UNITED STATES PATENT AND TRADEMARK OFFICE

APPLICATION NO.	FILING DATE	FIRST NAMED INVENTOR	ATTORNEY DOCKET NO.	CONFIRMATION NO.
10/091,533	03/07/2002	Shinichi Tanaka	D-1249	8370

Office Action Summary

DETAILED ACTION

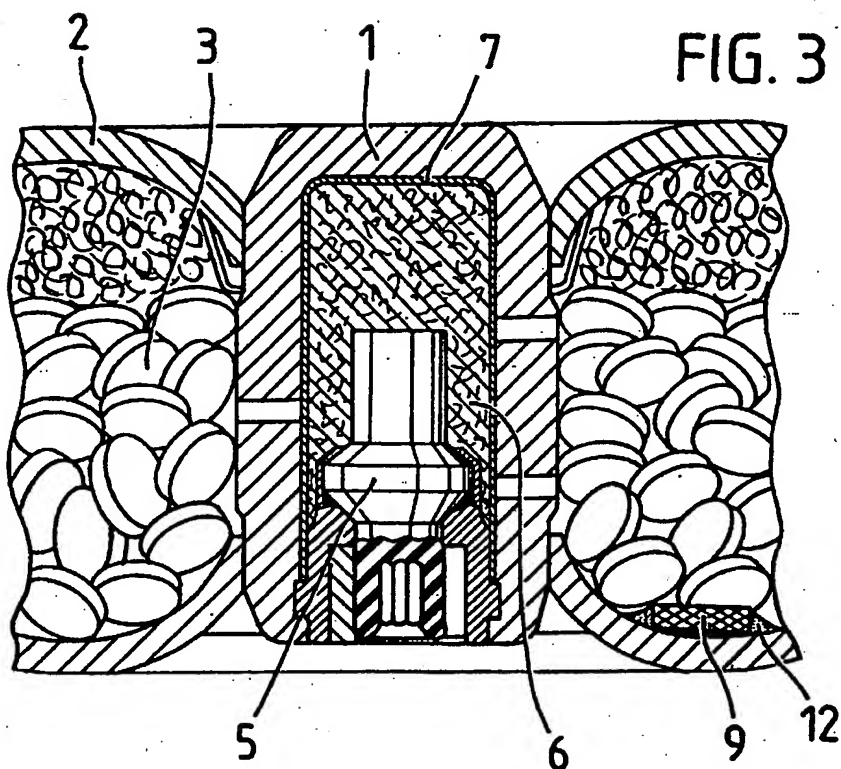
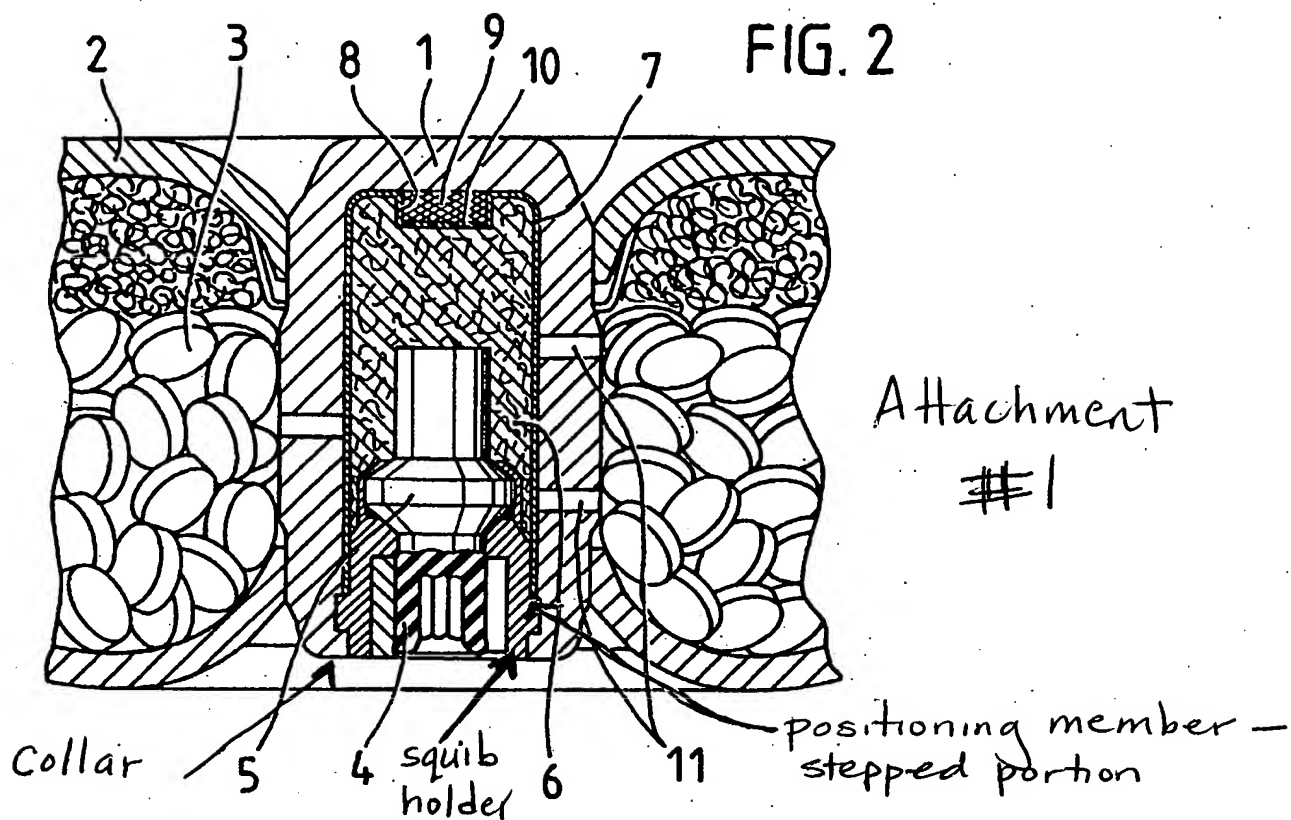
Claims 1 and 3 – 5 are rejected under 35 U.S.C. 102(b) as being anticipated by Zeuner et al. (US 5,501,152). Zeuner discloses an air bag gas generator including a container having an outer shell (2 in Fig. 2), a gas initiator disposed in the container (6 in Fig. 2), an igniter disposed adjacent to the gas initiator for igniting the gas initiator (5 in Fig. 2), and a partition (1 in Fig. 2) disposed in the outer shell for dividing the container into a plurality of gas initiator chambers (6, 3 in Fig. 2) and having a positioning member (see attachment #1) for positioning the igniter inside the partition. The positioning member is a stepped portion extending from an end of the partition (see attachment #1). The igniter is a squib (5 in Fig. 2) in a squib holder (see attachment #1) for supporting the squib, and the squib holder is positioned by the positioning

member inside the partition. The partition also includes a collar for holding the squib holder between the positioning member and the collar (see attachment #1).

Attachment
2

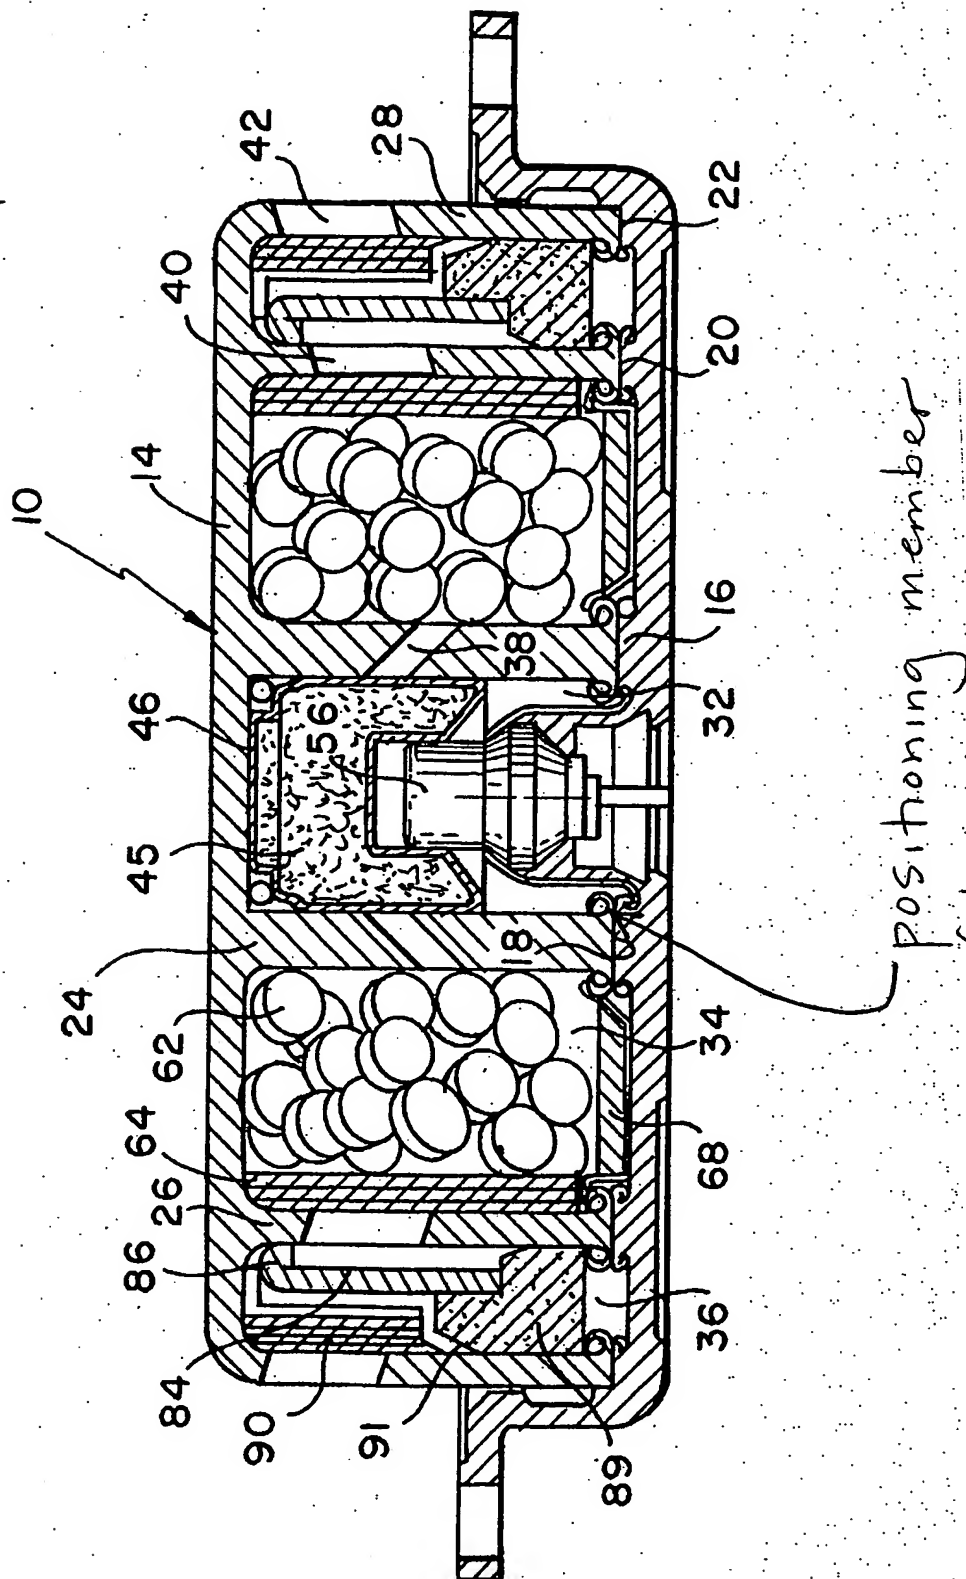
Claims 1 and 2 are rejected under 35 U.S.C. 102(b) as being anticipated by Hock et al. (US 5,613,705). Hock discloses an airbag inflator including a container having an outer shell (14, 16 in Fig. 1), a gas initiator disposed in the container (45 in Fig. 1), an igniter disposed adjacent to the gas initiator for igniting the gas initiator (56 in Fig. 1), and a cylindrical partition (24 in Fig. 1) disposed in the outer shell for dividing the container into a plurality of gas initiator chambers (45, 34 in Fig. 1) and having a positioning member (see attachment #2) for positioning the igniter inside the partition. The positioning member is composed of projections projecting from an inner peripheral surface of the partition (see attachment #2).
